# Access Compliance Report

## Public Rights-of-Way

| Intersection ID: 11642 | Main Street: N_POPLAR_ST | Cross Street: W_9TH_ST  | Location: E            |
| ADA ID: 0638E78A11C2   | Ramp Type: PerpDiag      | Initial Pass/Fail: Fail | Overall Compliance: No |

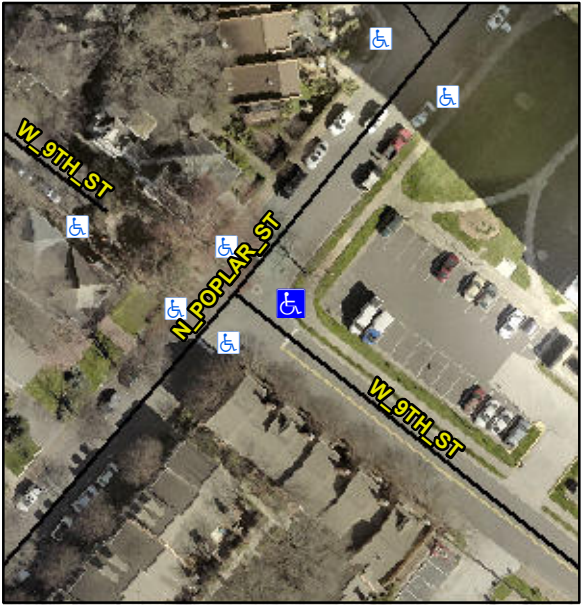
| Codes/Mitigation Info/Possible Solution                                                    |                                                                                     |  | Field Measurements/Component Compliance |                          |             |
|--------------------------------------------------------------------------------------------|-------------------------------------------------------------------------------------|--|-----------------------------------------|--------------------------|-------------|
| <p>Surveyor Notes:</p> <p><b>N/A</b></p> <p>PROW/ADA:</p> <p><b>R304.2.2, R304.5.3</b></p> |                                                                                     |  | N/A                                     | Flare Type RT            | N/A         |

| Codes/Mitigation Info/Possible Solution                                                    |                                                                                     |  | Field Measurements/Component Compliance |                          |             |
|--------------------------------------------------------------------------------------------|-------------------------------------------------------------------------------------|--|-----------------------------------------|--------------------------|-------------|
|                                                                                            | <b>Remove &amp; Replace Curb Ramp With Two New Directional Ramps or Equivalent.</b> |  | N/A                                     | Ramp Length (in)         | 64.0        |
